Subject: RE: Springfield, Hook Lane - AL/64/20/PL

The Engineering Details Drainage Strategy for the site as illustrated (dwg. no. 602-01, Rev C) is broadly respectful of retained trees and their growth potential, with the obvious exception being chosen route of surface water discharge to the north boundary watercourse and construction of headwall – both within the RPA of retained (off-site?) mature Cypress T21. Directional drilling technique is proposed 'if required'. I say it is necessary unless exploratory excavation findings permit standard trenching. All that to be set out in the required Arboricultural (Impact Assessment &) Method Statement. ***Might it not be easier to take a more northerly route from manhole S8 and avoid significant tree's (T18 & T21) RPA altogether***, subject to suitable ground levels (gravity connection)?

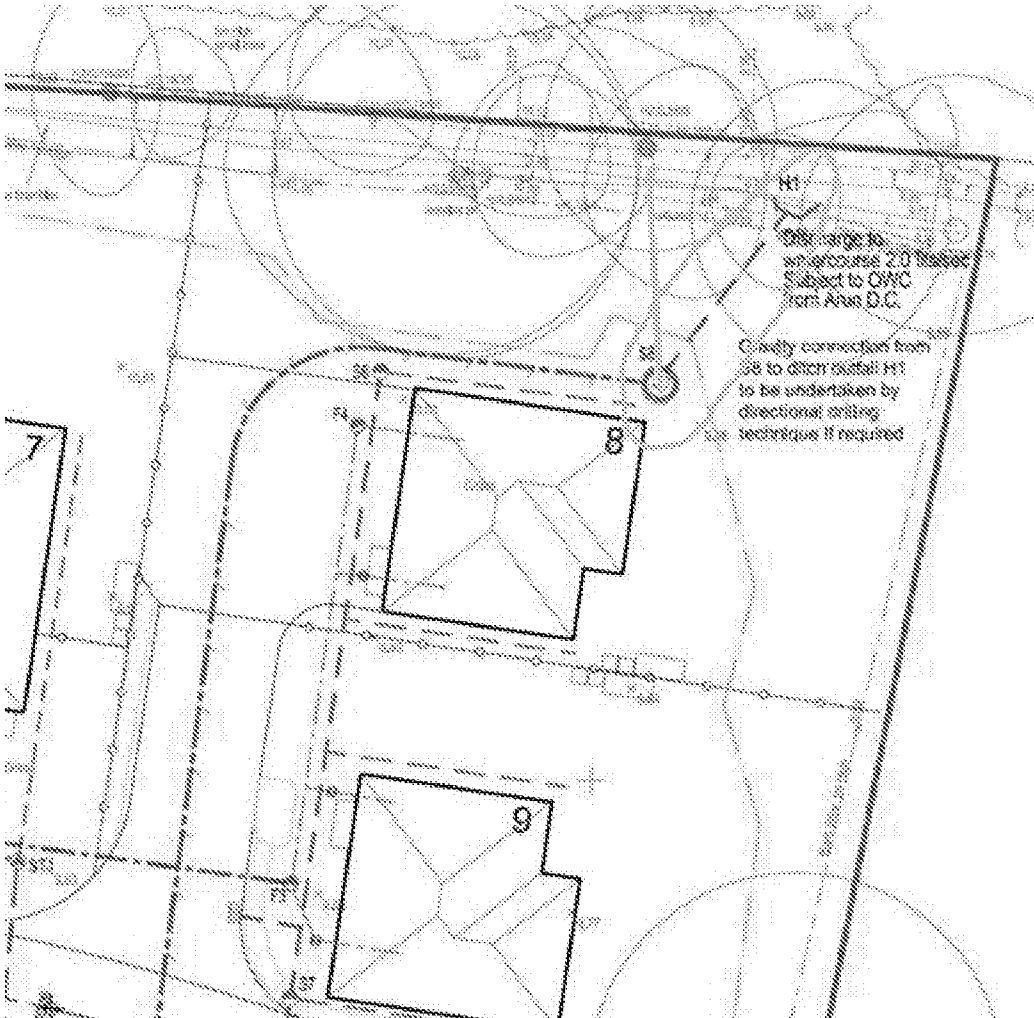
I have highlighted the relevant part regarding the suggested re-routing of the drainage run as whilst we appreciate the drainage is currently shown heading north-east from manhole S8 and would be within the edge of the RPZ of T21 (circled in orange) if we move the drainage run to a more northerly position from S8 (orange arrow) as suggested this would encroach more within the RPZ of T18, which I believe is a Category B tree (T21 being a C category tree). We are keen to work with you to make revisions and at present the drainage scheme is only indicative however we want to make sure any changes address Mark's concerns in order to present the application with the best chance of success before Committee. As such we would be grateful for any comments you may have in this regard.

- (1) You amend the Method Statement to make it implicit that exploratory excavation will be carried out and if roots are present along the drainage channel line then directional drilling to take place; or
- (2) You take a new drainage run in a northerly direction (not quite straight north) and aim to bisect the RPAs of onsite T18 and offsite T21.

Mark states his preference is (1) but would be happy with either. I trust this assists.
